UNITED STATES
NUCLEAR REGULATORY COMMISSION
WASHINGTON, D. C. 20555

INDIAN POINT STATION, UNIT NO. 1

Amendment No. 29
License No. DPR-5

ATTACHMENT TO LICENSE AMENDMENT NO. 29
PROVISIONAL OPERATING LICENSE NO. DPR-5
DOCKET NO. 50-3

Figure 3.1 Facility Management and Technical Support Organization

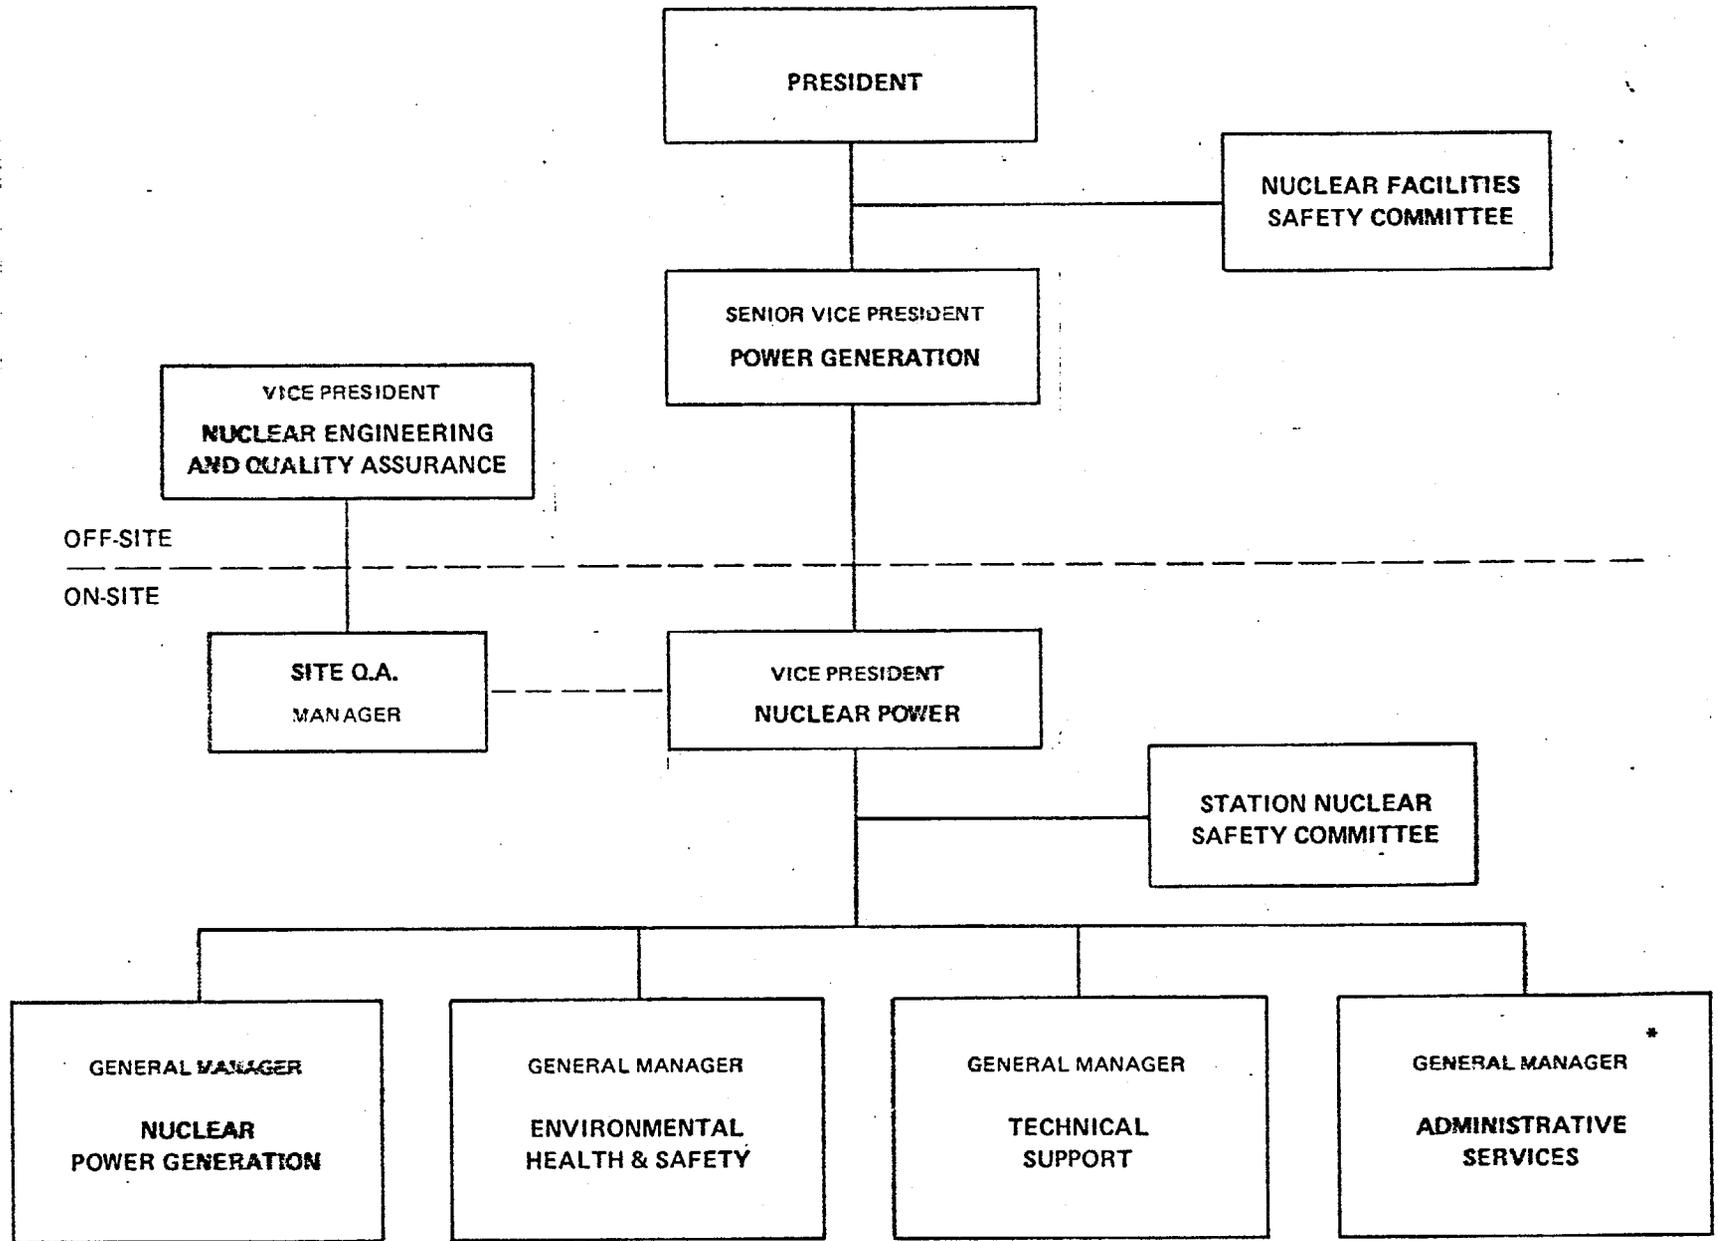
3.1.1 The organization for facility management and technical support shall be as shown in Figure 3.1.

Figure 3.2 Facility Organization

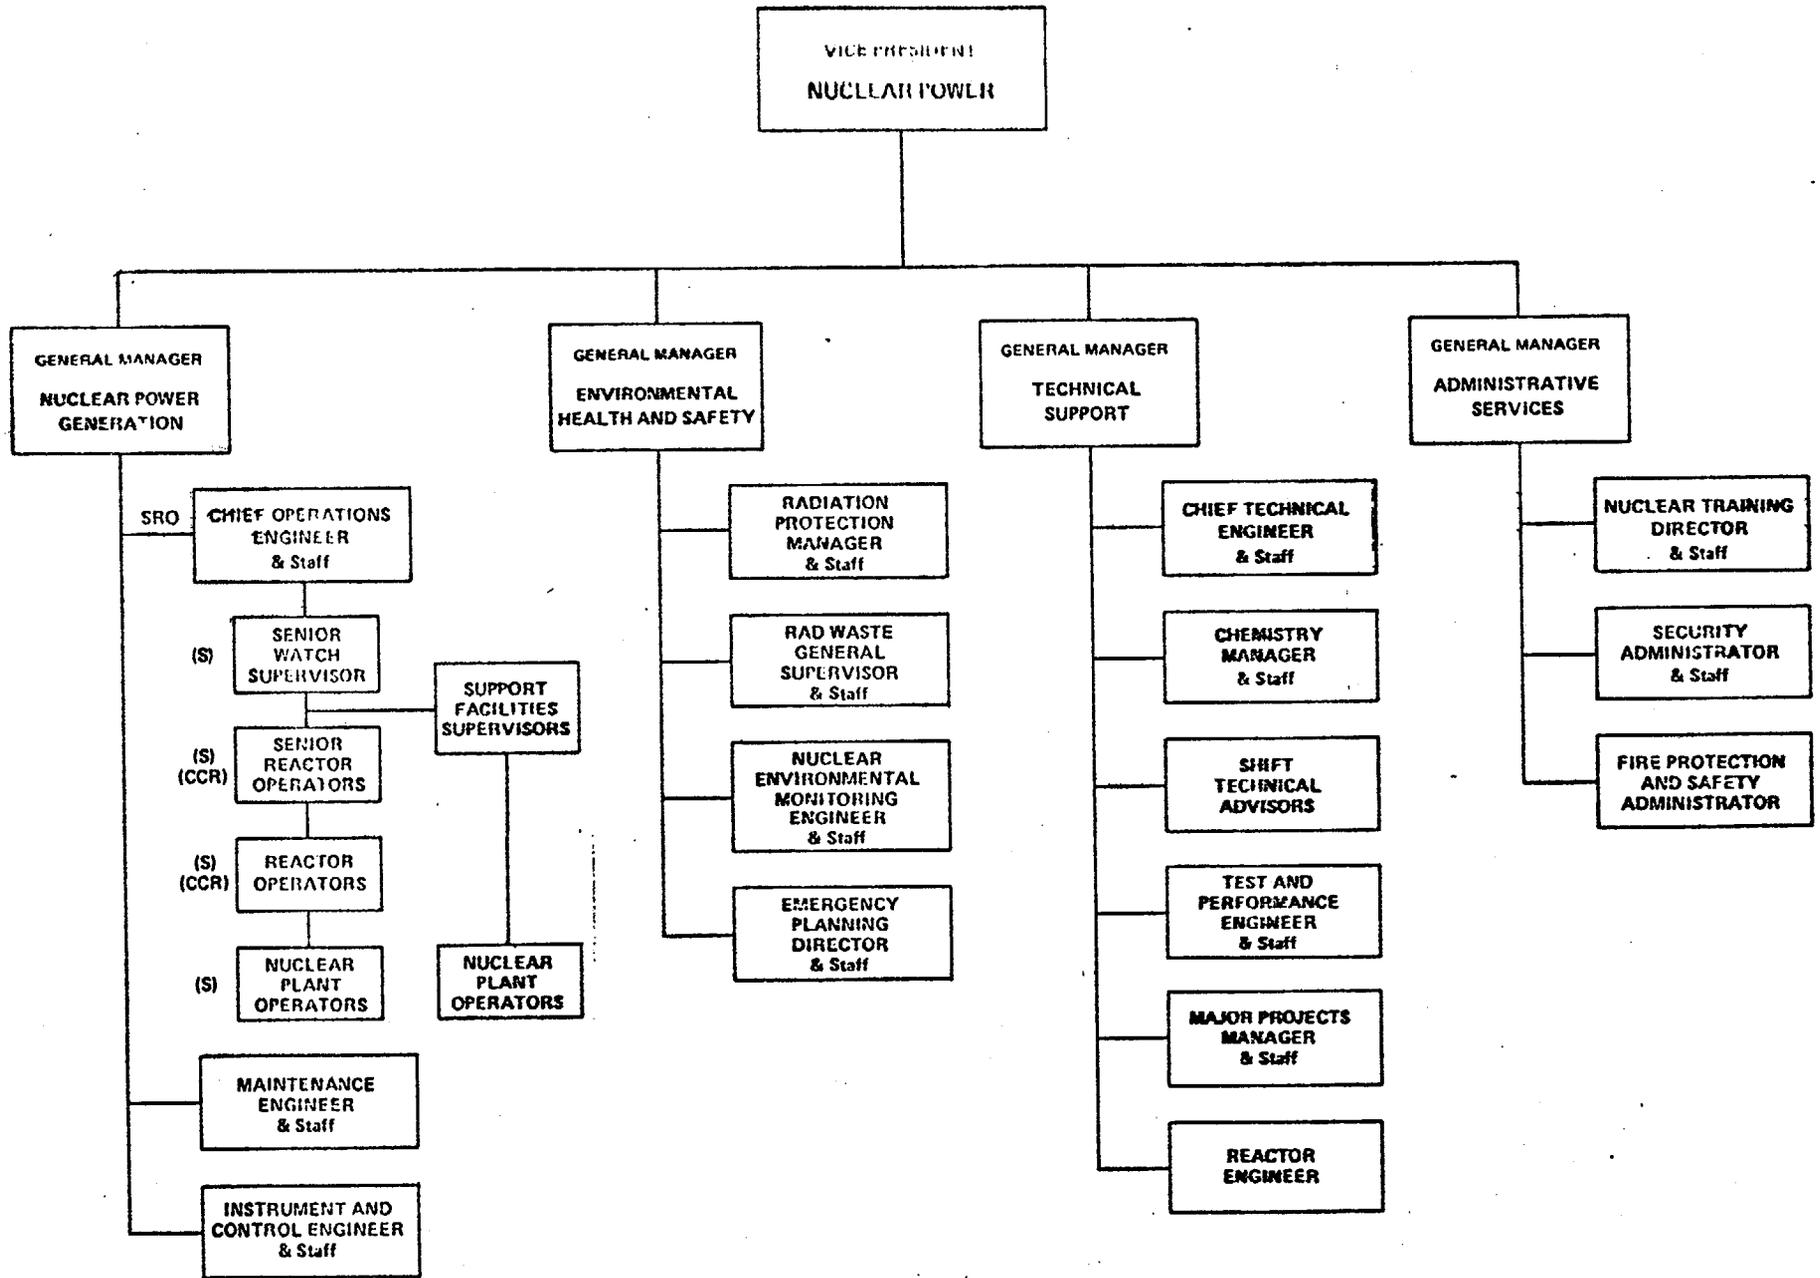
3.1.2 The Facility Organization shall be as shown in Figure 3.2. The Support Facilities Supervisor is responsible for operations at the Unit No. 1 facility.

3.1.3 The Vice President-Nuclear Power shall be responsible for overall facility activities as shown in Figure 3.2 and shall delegate in writing the succession to this responsibility during his absence.

3.1.3.1 The General Manager-Nuclear Power Generation shall be responsible for facility operations as shown in Figure 3.2 and shall delegate in writing the succession to this responsibility during his absence.

Figure 6.2-1 Facility Management and Technical Support Organization

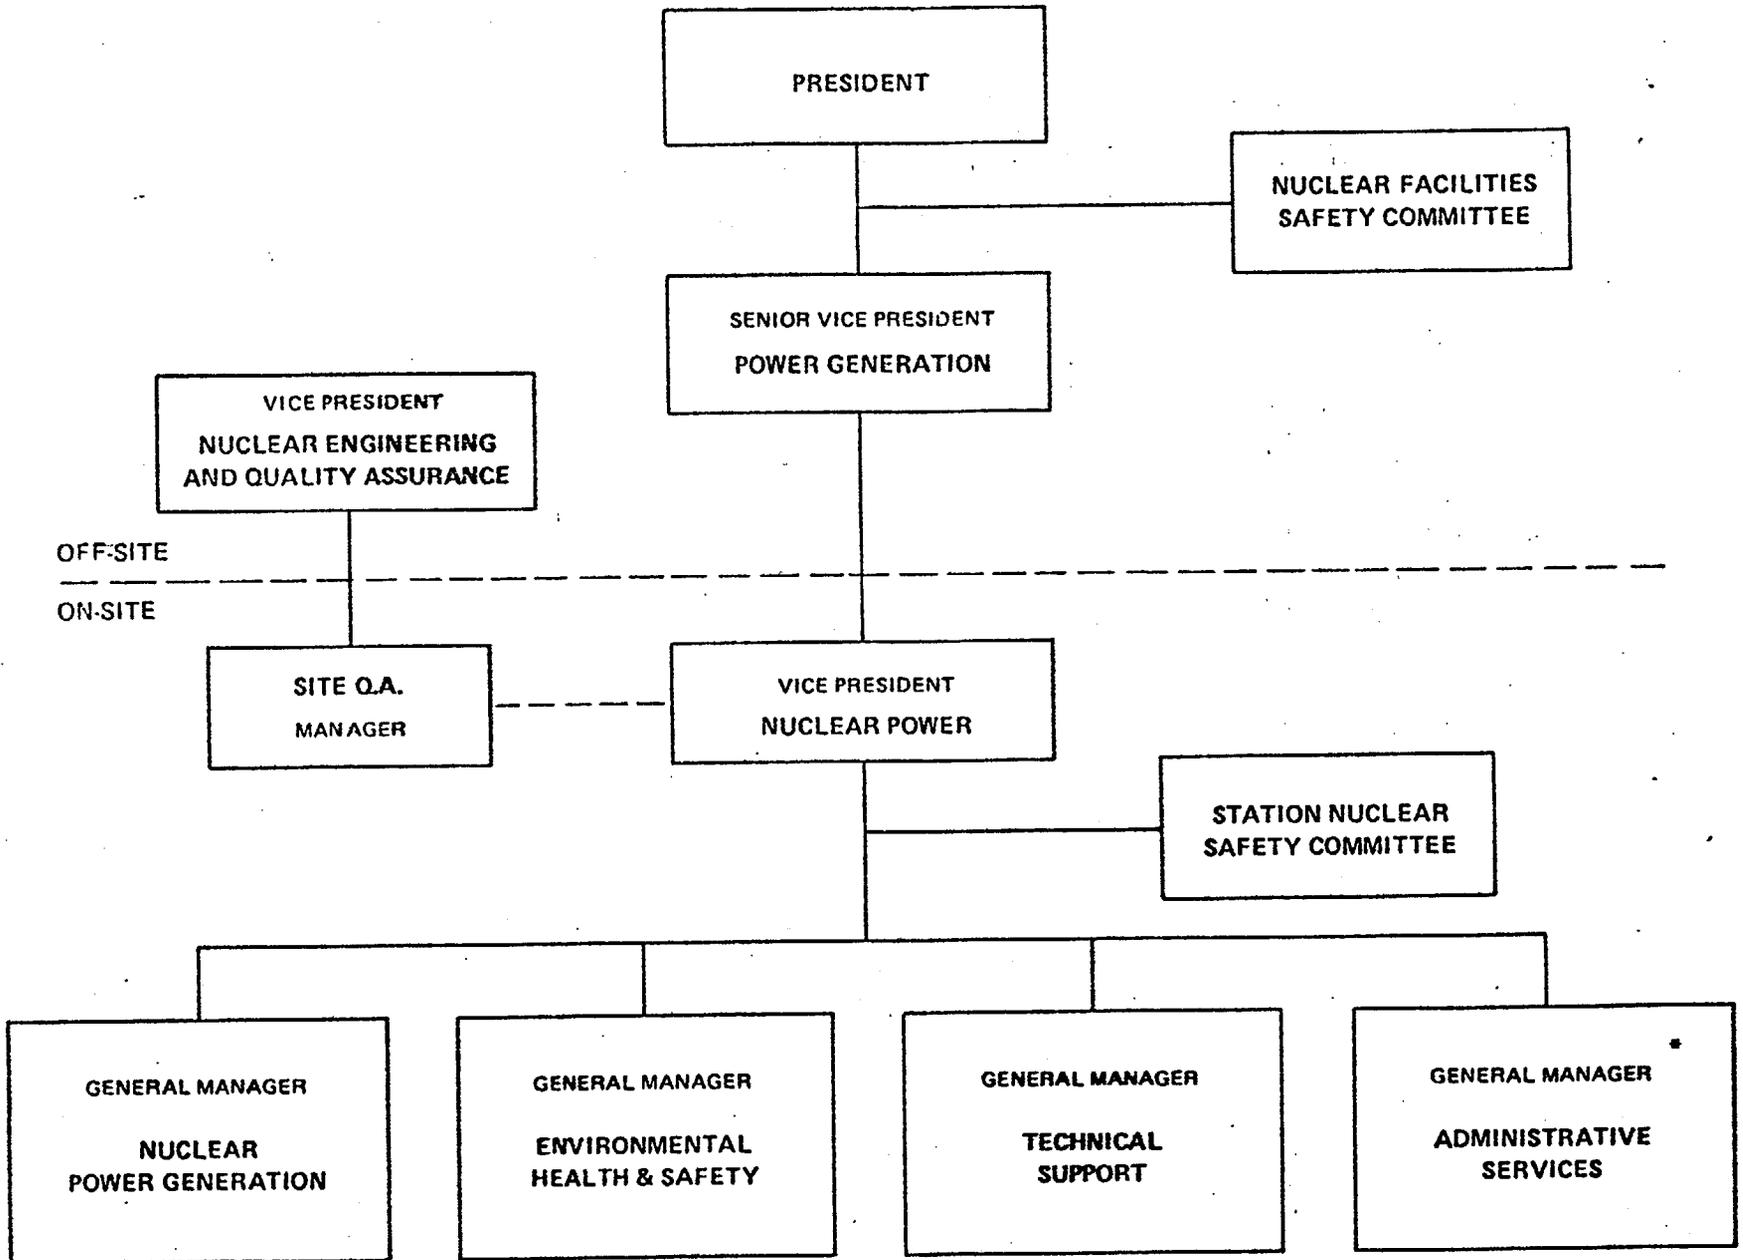
6.2.1 The organization for facility management and technical support shall be as shown on Figure 6.2-1.

Figure 6.2-2 Facility Organization

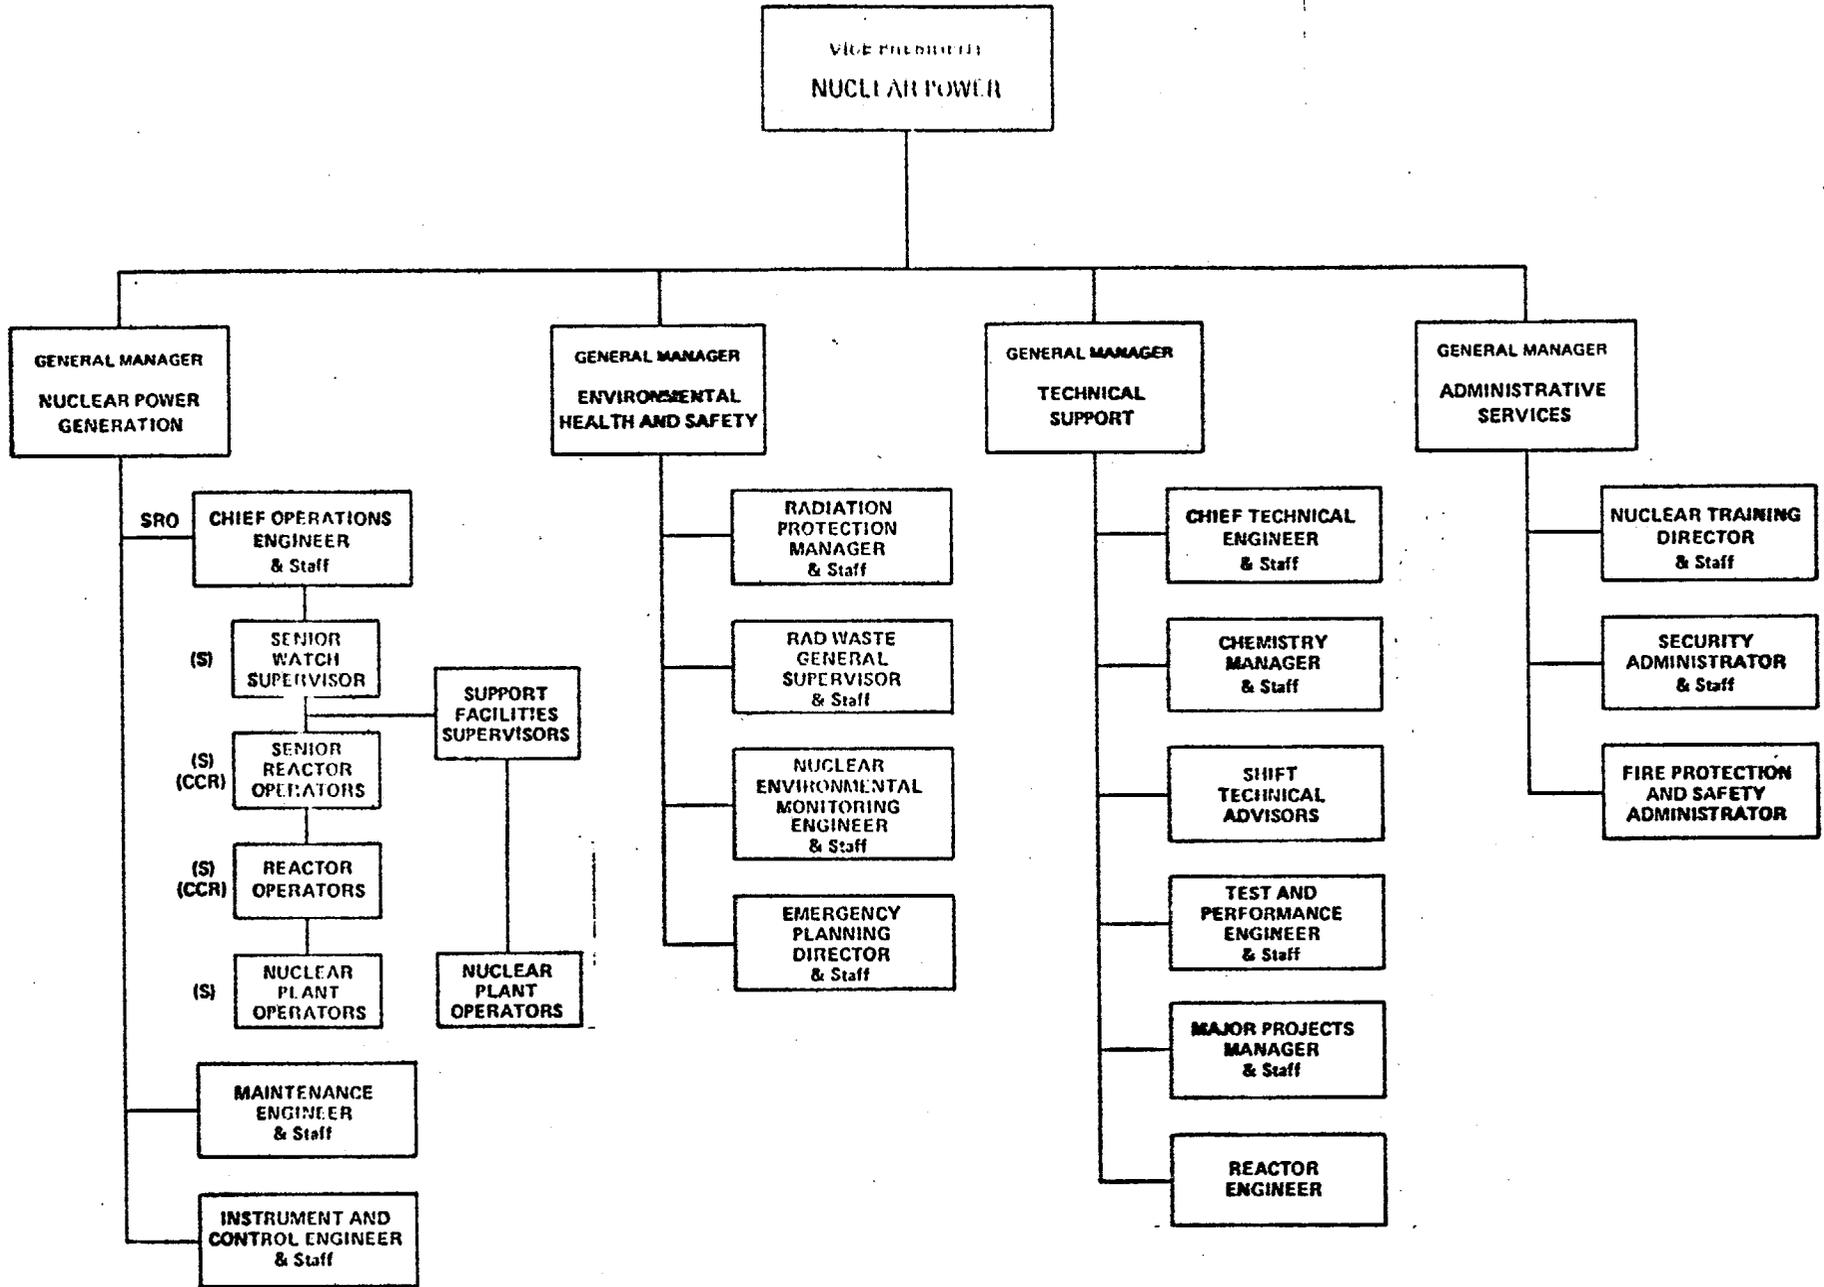
6.1.1 The Vice President-Nuclear Power shall be responsible for overall facility activities as shown in Figure 6.2.2 and shall delegate in writing the succession to this responsibility during his absence.

6.1.2 The General Manager-Nuclear Power Generations shall be responsible for facility operations as shown in Figure 6.2.2 and shall delegate in writing the succession to this responsibility during his absence.

6.2.2 The Facility organization shall be as shown on Figure 6.2-2 and:
